Pedestrian Device Guidance Workgroup

I. Pedestrian Warrants

B) Proposed

Figure 4C-5. Warrant 4, Pedestrian Four-Hour Volume

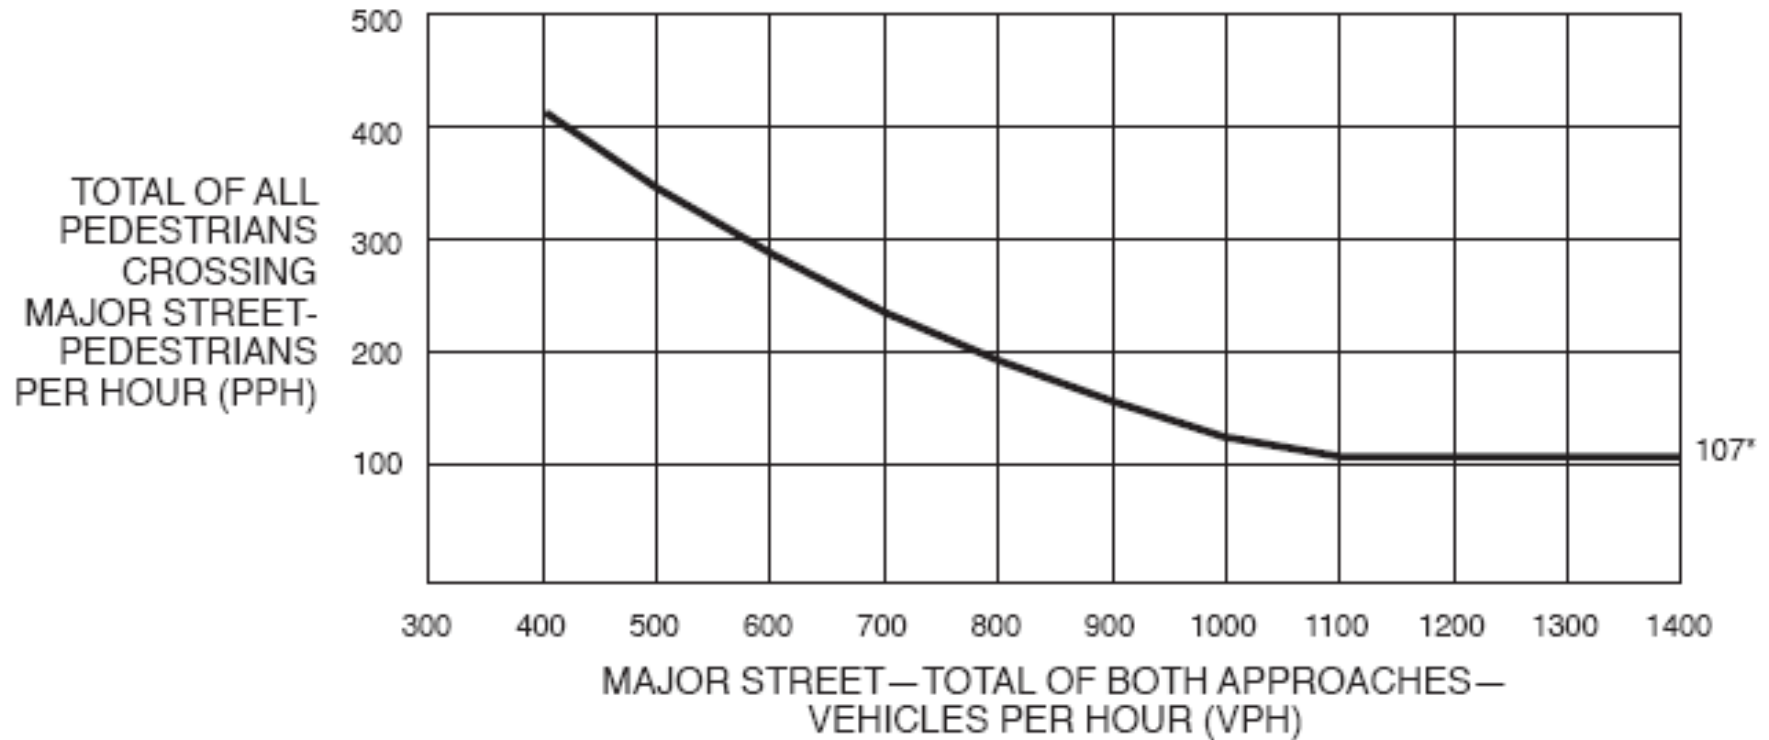
For each of any 4 hours of an average day, the plotted points representing the vehicles per hour on the major street (total of both approaches) and...

... the corresponding pedestrians per hour crossing the major street (total of all crossings) all fall above the curve in Figure 4C-5; or...

*Note: 107 pph applies as the lower threshold volume.

Figure 4C-6. Warrant 4, Pedestrian Peak Hour

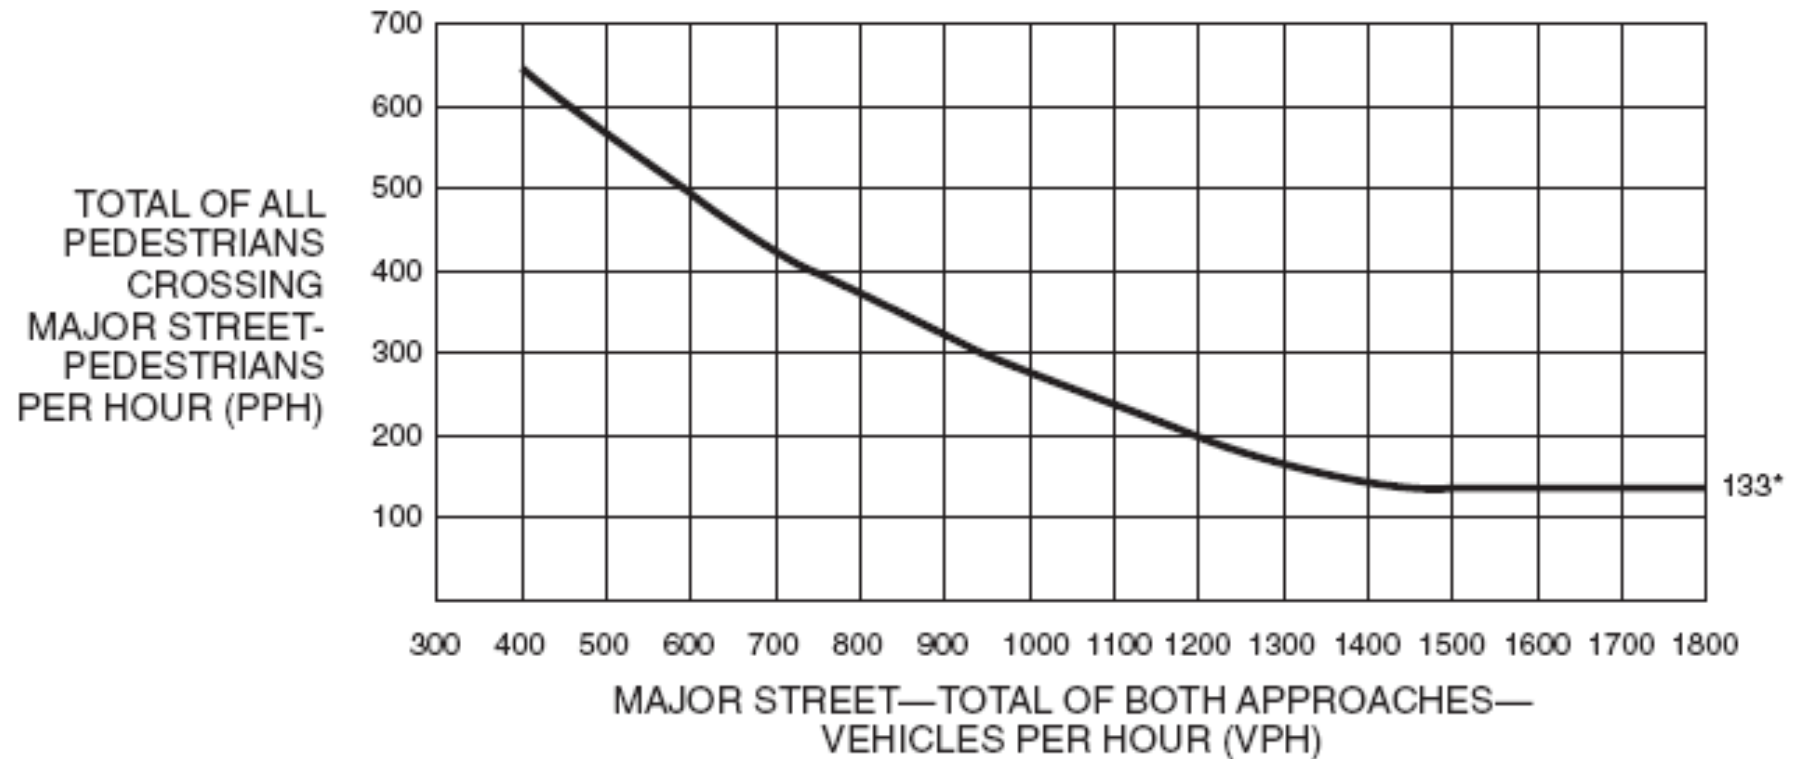
For one hour (any four consecutive 15-minute periods) of an average day, the plotted point representing the vehicles per hour on the major street (total of both approaches) and ...

... the corresponding pedestrians per hour crossing the major street (total of all crossings) falls above the curve in Figure 4C-6.

*Note: 133 pph applies as the lower threshold volume.

Figure 4C-8. Warrant 4, Pedestrian Peak Hour (70% Factor)

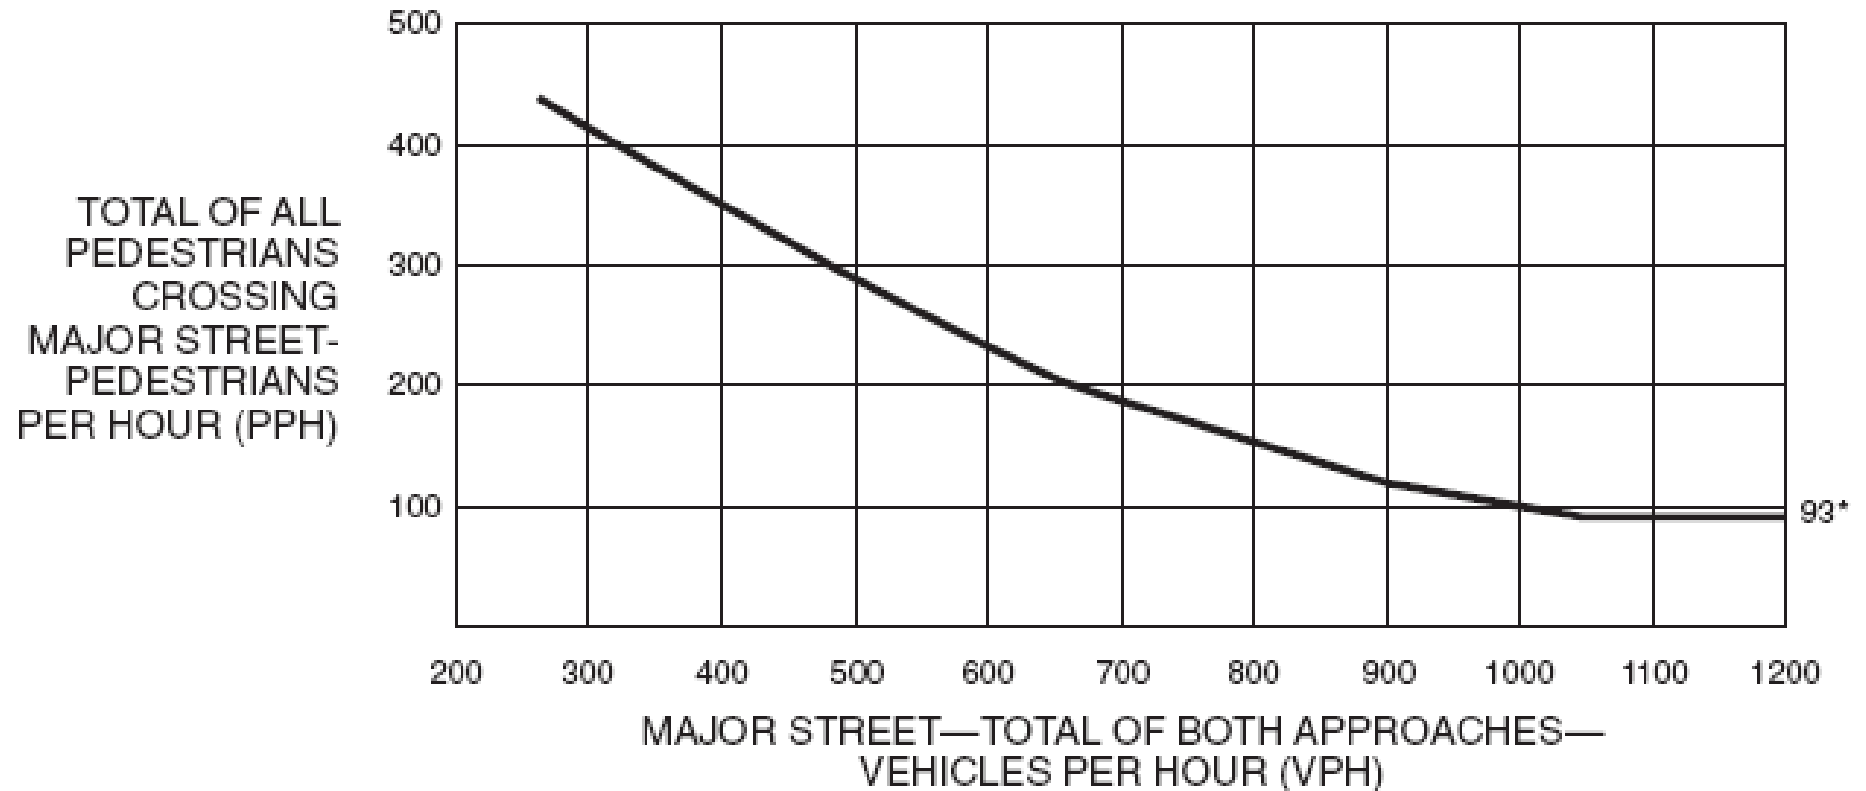
... and Figure 4C-8 may be used in place of Figure 4C-6 to satisfy Criterion B.

*Note: 93 pph applies as the lower threshold volume.
